Submission to the Planning Inquiry
PROOF OF EVIDENCE – DELIVERY & CONSTRUCTION RISKS
[MATTERS 1, 2, 4, 5, 9, 12 & 14]
Prepared by R. Harman CEng MCISBE

**Scheme: Application by Oxfordshire County Council : planning application number
R3.0138/21**

**Title: Dualling of the A4130 carriageway, construction of the Didcot Science Bridge, road
bridge over Appleford railways sidings and road bridge over the river Thames and
associated works between:**

CASE REF: APP/U3100/V/23/3326625.

SCIENCE BRIDGE – POTENTIAL HEAVY LIFT PLAN
[A4130 & MILTON ROAD]

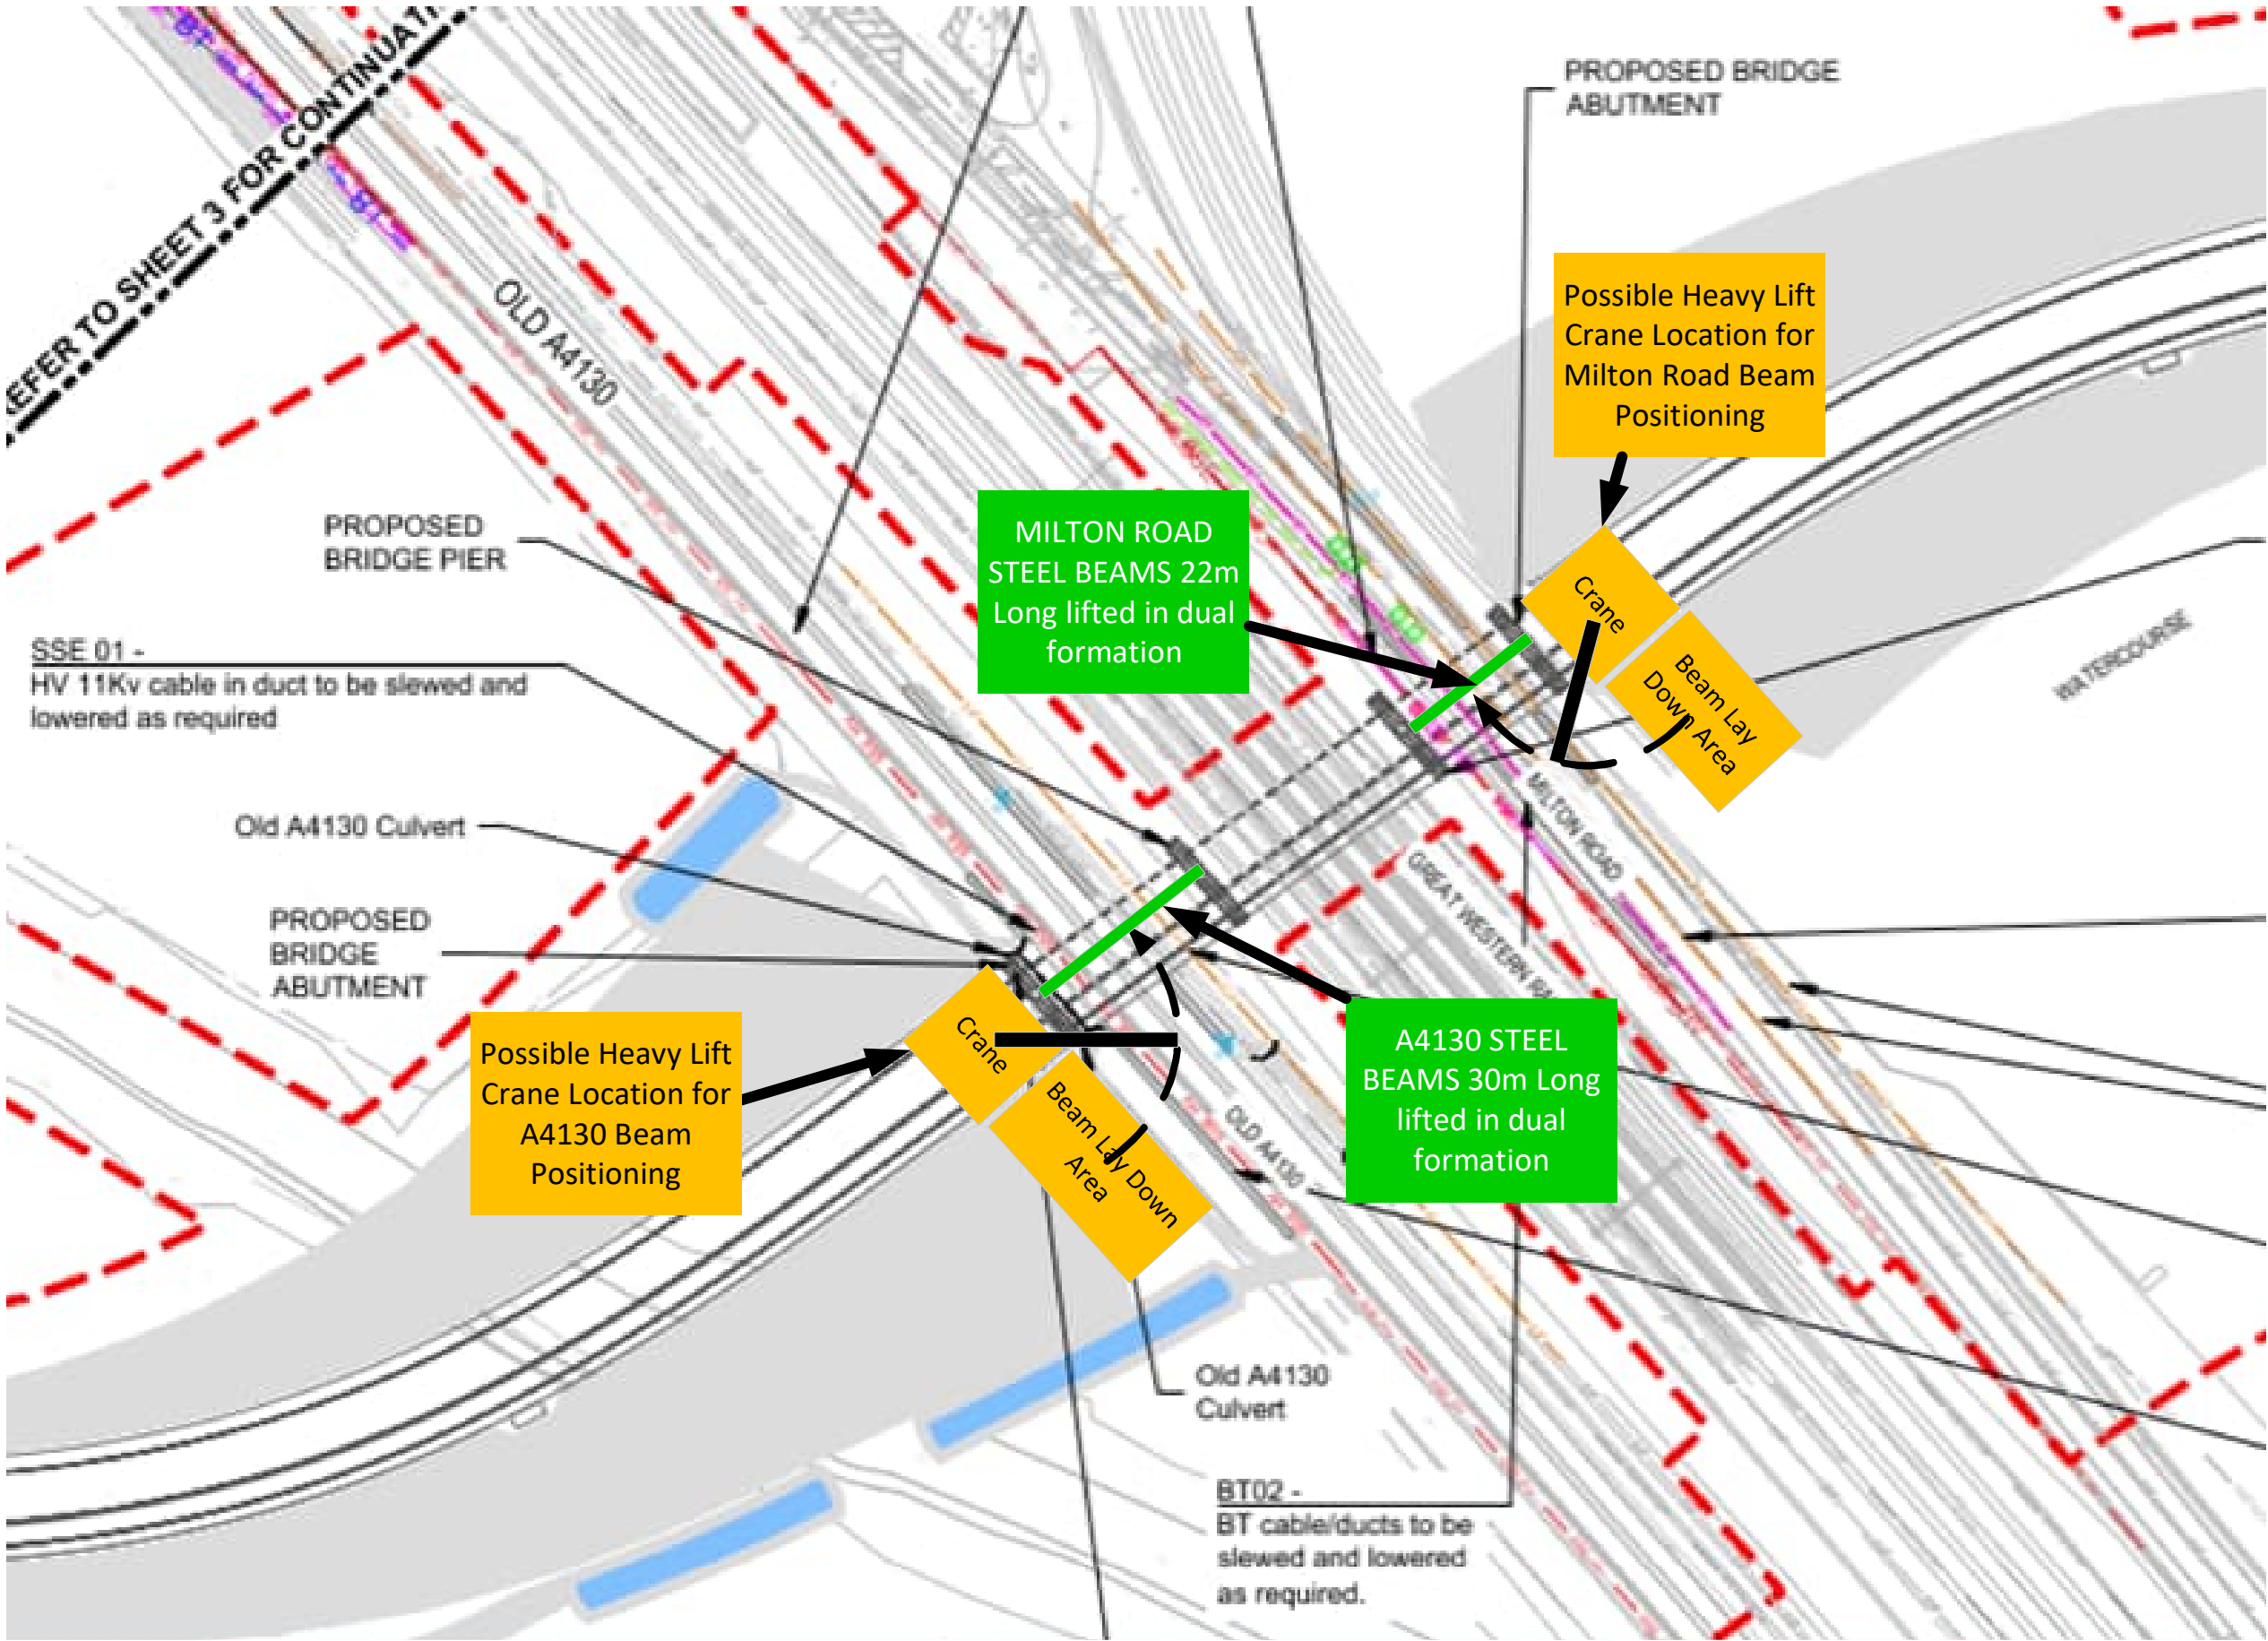
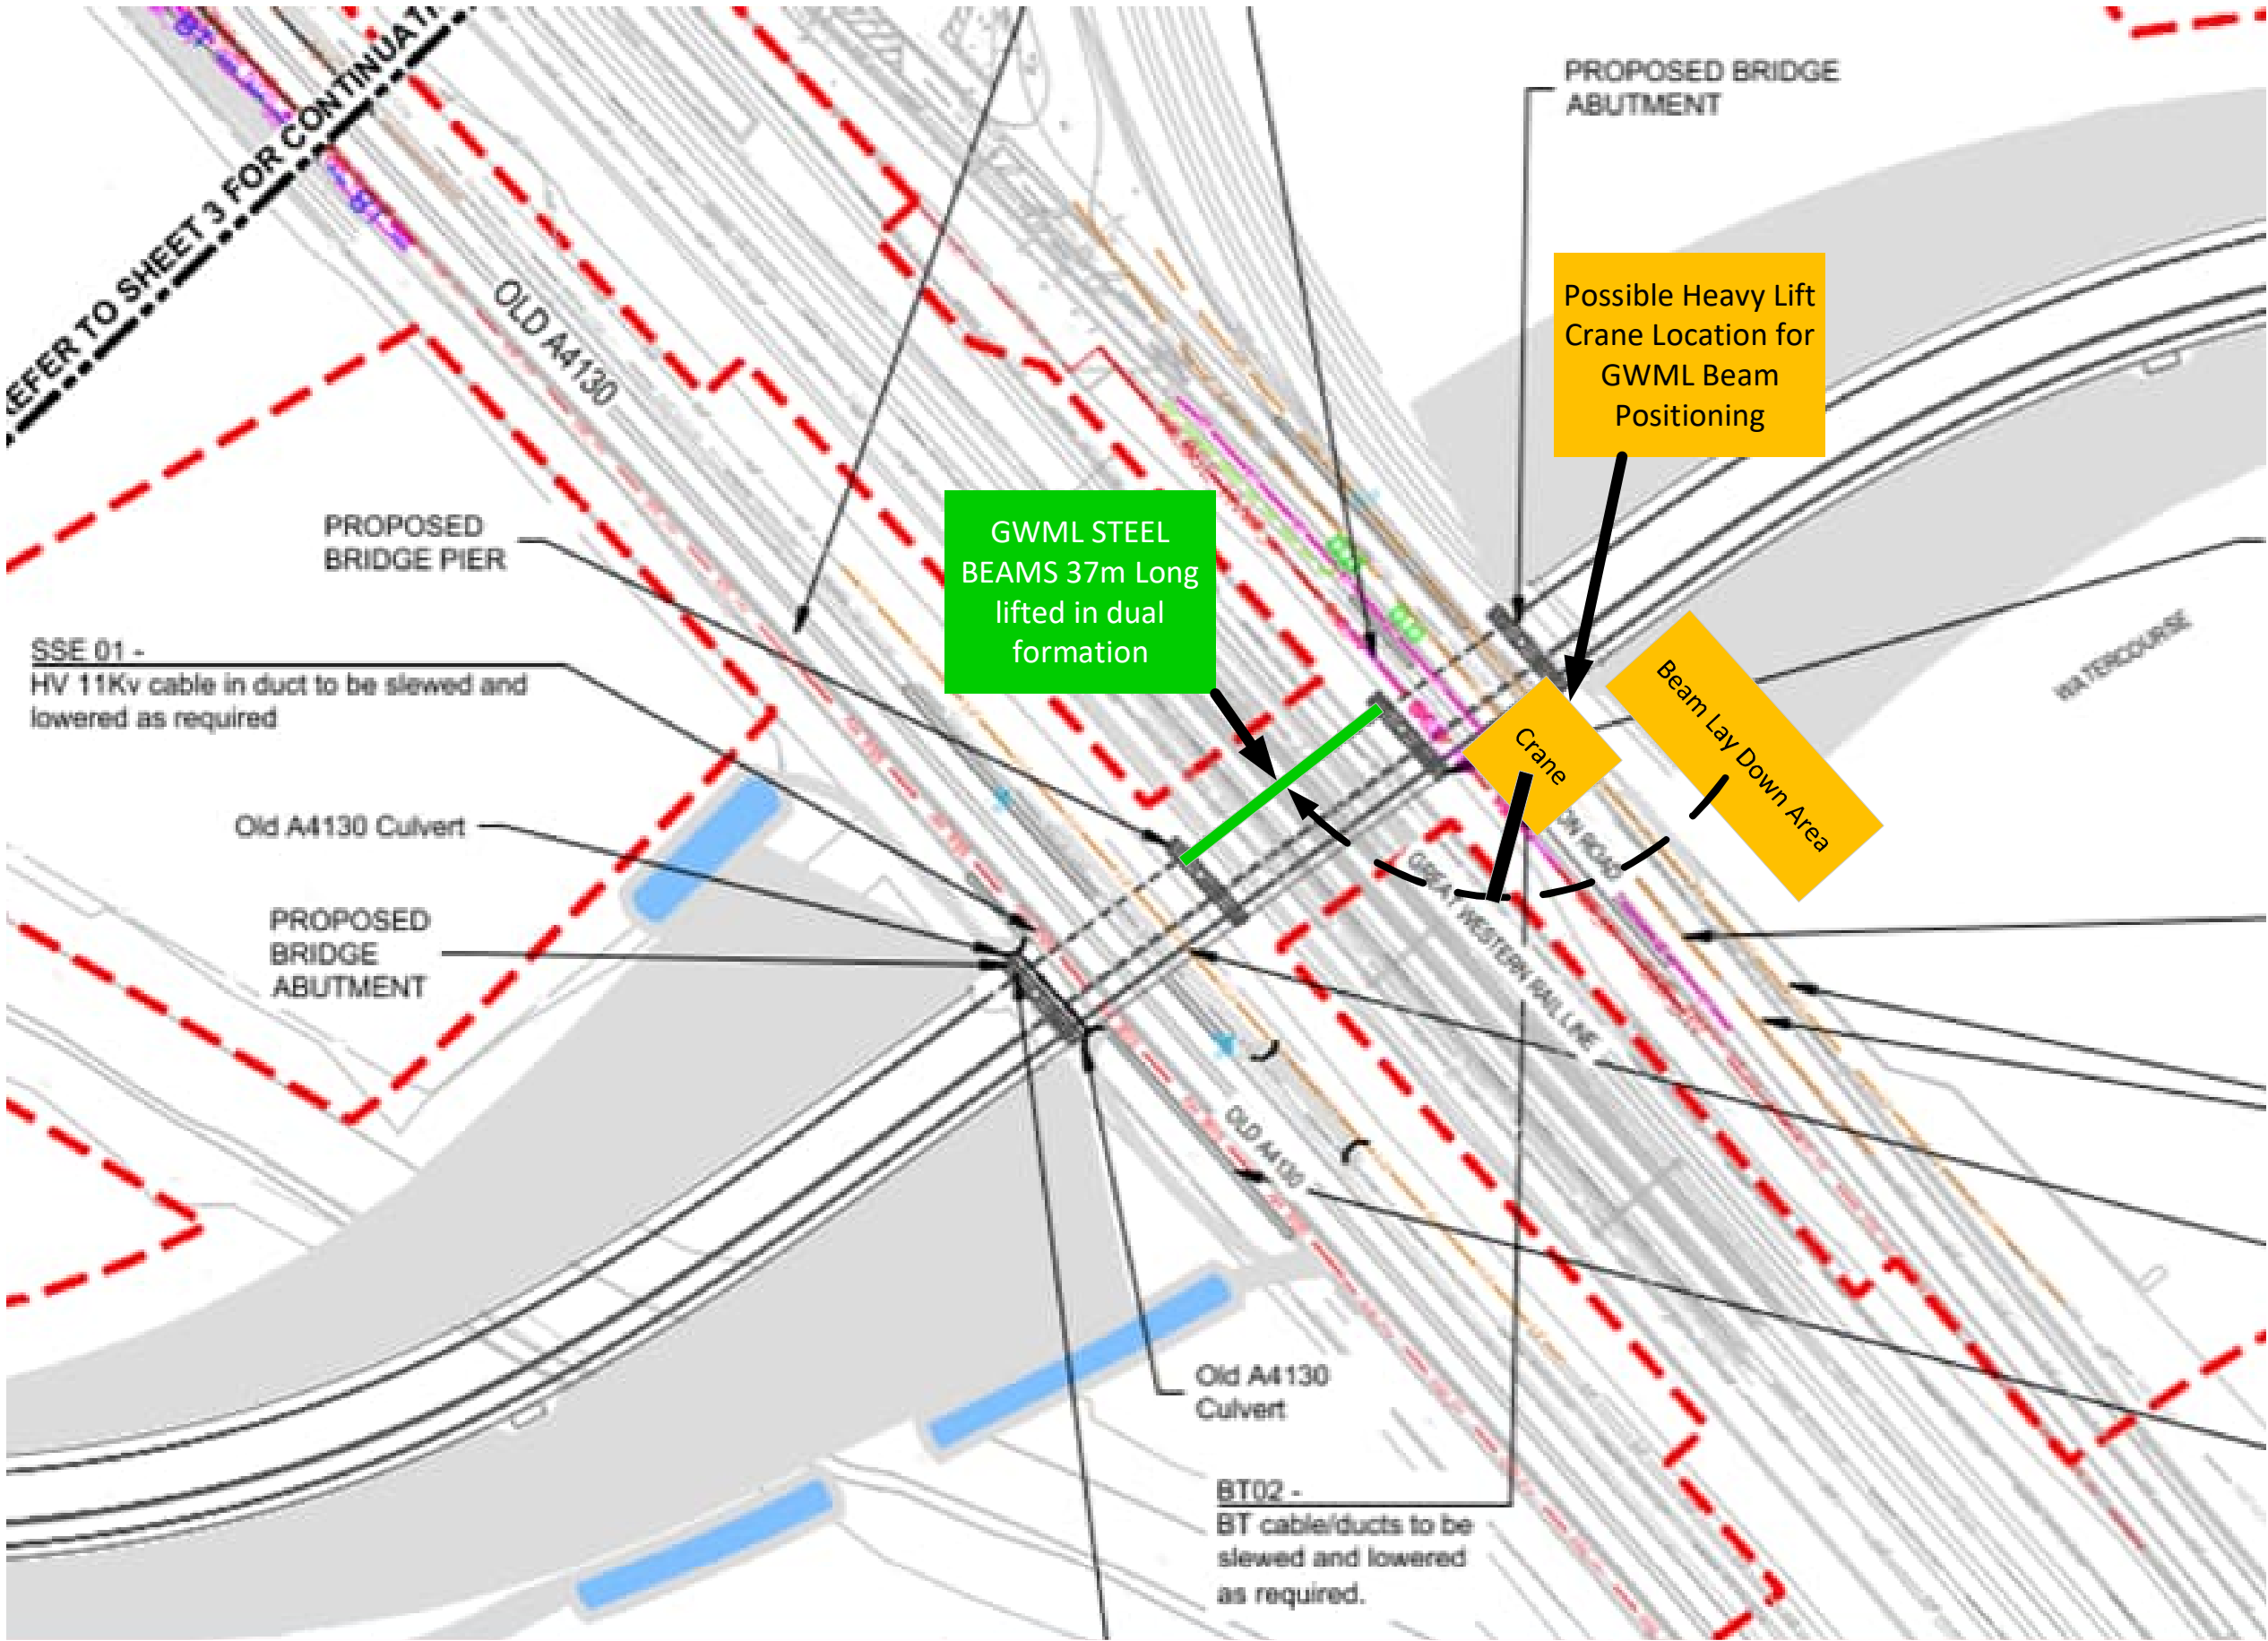
For the A4130 30m Steel I Beams to be located into position, it is likely the Contractor may choose to locate the Heavy Lift Crane to the south of the A4130 within the Contractors Worksite. *[See Drawing R3-01238-21-DATOM-002.]* The A4130 will need to be closed during the lifting and positioning of the 30m Steel I Beams I would estimate this would take 3No nightshift closures, 2No nightshift closures for the placement of Permanent Formwork and further 4No nightshift closures for the placement of the pre-constructed Parapets. These may not be consecutive closures.

For the Milton Road 22m Steel I Beams to be located into position, it is likely the Contractor will choose to locate the Heavy Lift Crane to the north of the Milton Road within the Contractors Worksite. *[See Drawing R3-01238-21-DATOM-002.]* Milton Road will need to be closed during the lifting operations of the 22m Steel I Beams. I would estimate this would take 3No nightshift closures, 2No nightshift closures for the placement of Permanent Formwork and further 4No nightshift closures for the placement of the pre-constructed Parapets. These may not be consecutive closures.

Road to the east side of the Science Bridge. [\[See Drawing R3-01238-21-DATOM-002.\]](#) Milton Road will need to be closed during the lifting operations. I would estimate this would take 4 No 24 hour shift closures, 2 No nightshift closures for the placement of Permanent Formwork and further 4 No nightshift closures for the placement of the pre-constructed Parapets. These may not be consecutive closures.
